**Limited Notified Resource Consent Application From No.8 Studios
Limited To Establish A Screen Production Studio In The Rural Zone At
Gordon Road and 376 Parkhill Road, Te Awanga (RMA20210474)**

Pre-circulated expert submitter evidence - Traffic

Evidence of Joseph Paul Durdin for A M and C J Caseley and Others

Figure 11: Sketch of proposed improvements to Parkhill / Raymond intersection

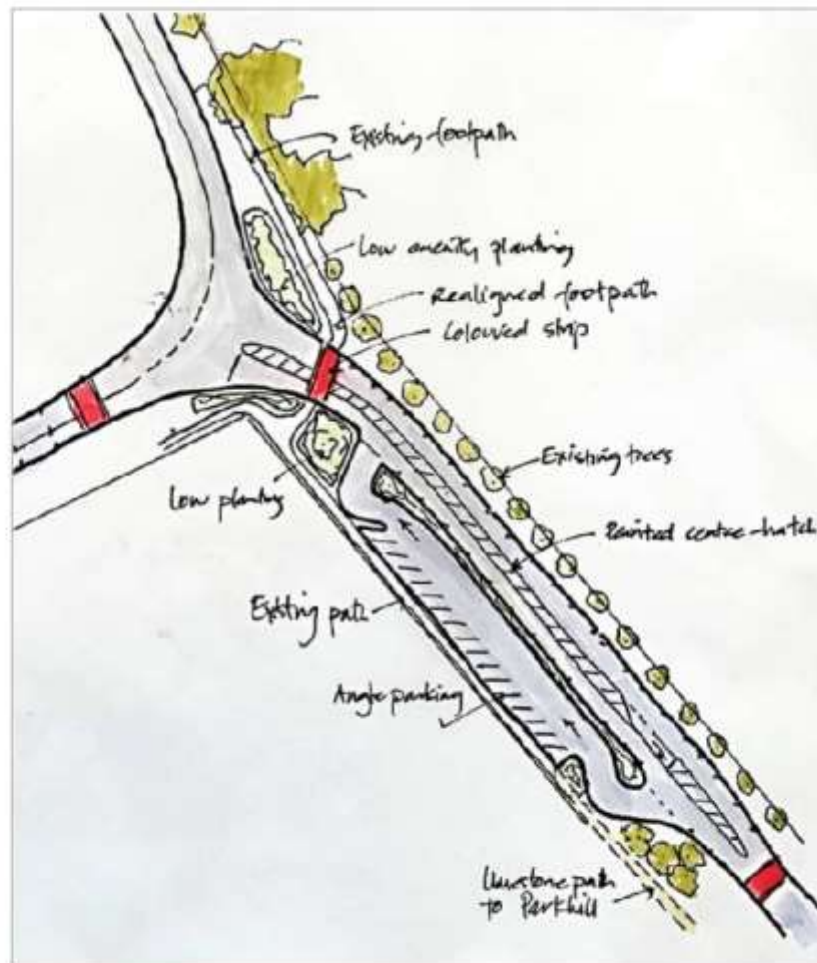
- 42 It is with interest therefore, that the Applicant has offered to deliver improvements (Figure 11) at the Parkhill / Raymond intersection "...in the vicinity of the Haumoana School and Te Awanga Kindergarten, recognising the importance of safety for these facilities in the community."³

- 44 To be clear, I do not oppose the proposed improvements. I support the introduction of the raised platforms and raised pedestrian crossing to enhance safety outcomes for vulnerable road users. I am simply questioning why such improvements would be put forward by an Applicant when no interaction between school or kindergarten users and users of the proposed activity is expected.

- 50 Whilst I support the introduction of the raised platforms and a raised pedestrian crossing to enhance safety outcomes for vulnerable road users, I have reservations about whether these improvements adequately mitigate the heightened risk that would exist.

- 51 Appendix C of Mr James' evidence shows a conceptual plan based on the indicative sketch included in the Application. I note with interest that the conceptual plan excludes the flush median and U-turn facility on Parkhill Road that exists in the sketch. I suspect it has been removed because the Applicant has realised that the road reserve is not wide enough to accommodate all features included in the indicative sketch.

- 52 I had a colleague determine the dimensions required for each of the facilities shown in the indicative sketch. Measured perpendicular to the direction of travel from the kindergarten side these are:

54.5 The proposed improvements included in the Application are unable to be accommodated within the current road reserve on Parkhill Road and are already being modified by the Applicant to reflect this.

55 Whilst supportive of the proposed improvements in and around the intersection, I have reservations about whether these improvements adequately mitigate the heightened risk that would exist with the increased turning traffic movements. It is also unclear what form the improvements would take, particularly on Parkhill Road, given the road reserve is currently not wide enough to accommodate these without compromising on one or more of the facilities.
